Product Change Notification / JAON-04IGFH099

CCB 4542 Initial Notice: Qualification of a new lead frame design for selected products available in 8L SOIC package using 8900NC die attach and gold (Au) bond wire material assembled at MMT assembly site.

CCB 4542
Pre and Post Change Summary
PCN # JAON-04IGFH099

Lead frame Comparison

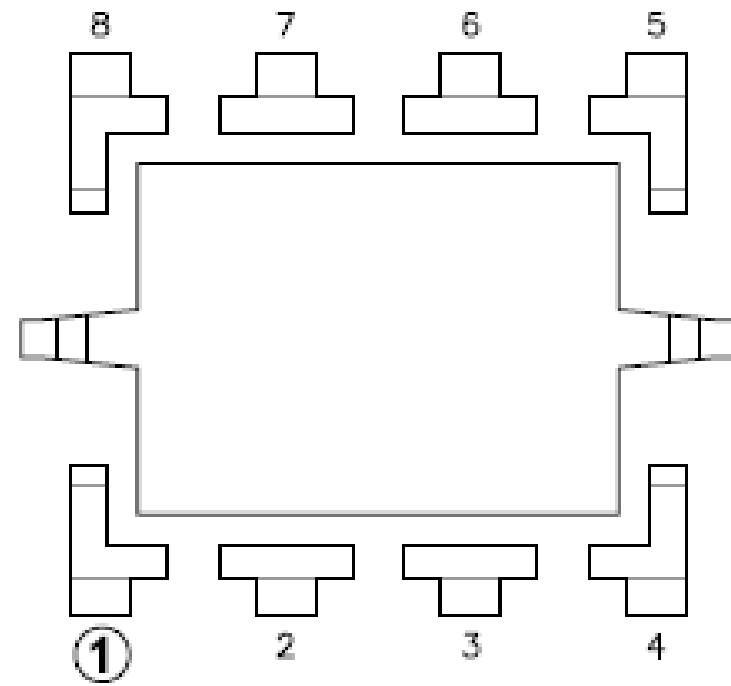
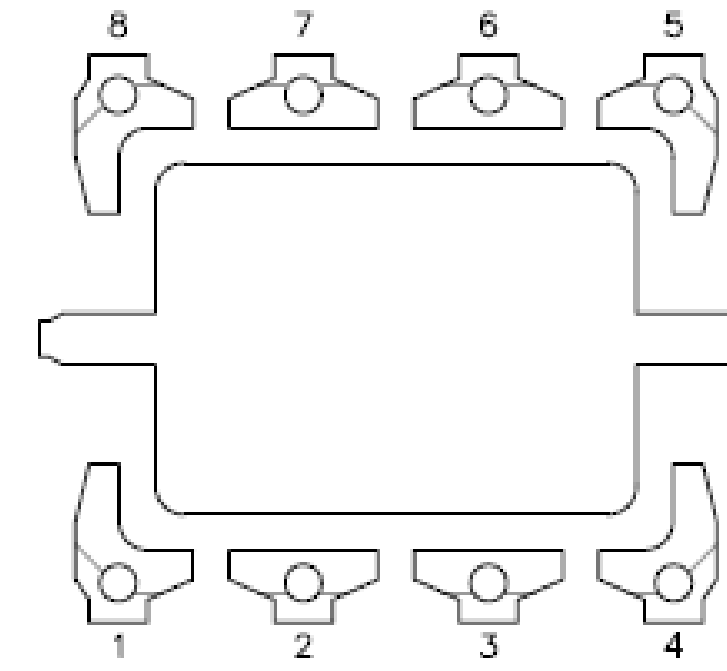
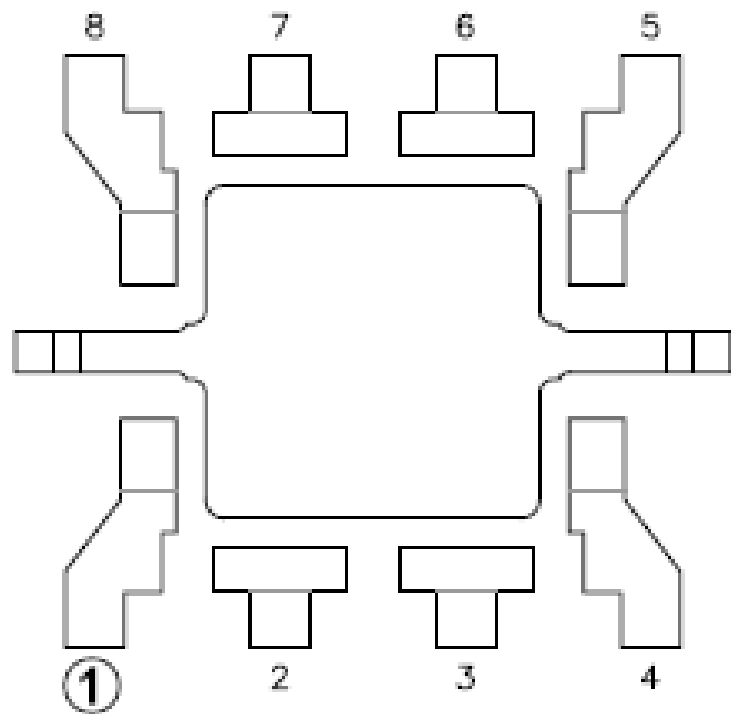
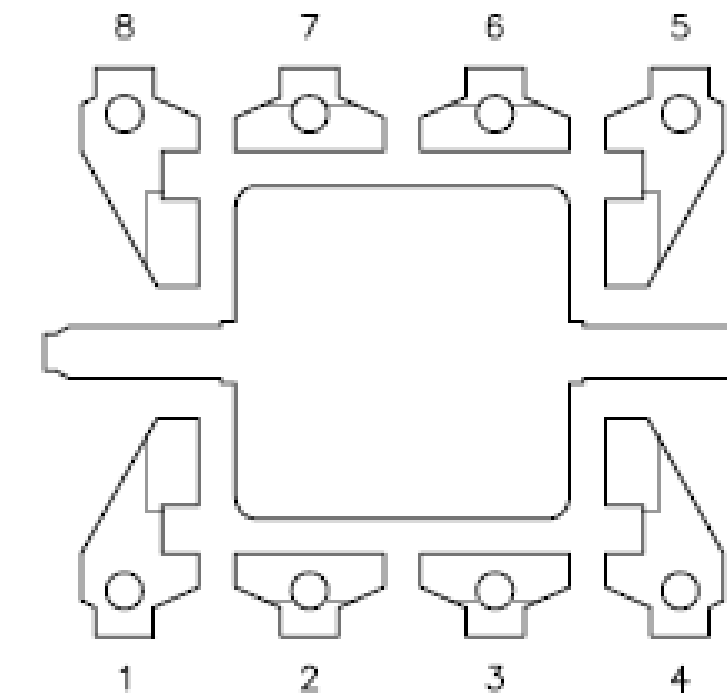
Pre Change:
Using lead frame without lead lock

Post Change:
Using lead frame with lead lock

Pre Change	Post Change
Assembly Site	Microchip Technology Thailand (Branch) / MMT	Microchip Technology Thailand (Branch) / MMT
Wire material	Au	Au
Die attach material	8900NC	8900NC
Molding compound material	G600V	G600V
Lead frame material	CDA194	CDA194
Lead Frame Lead Lock	No	Yes
	See attached pre and post change comparison
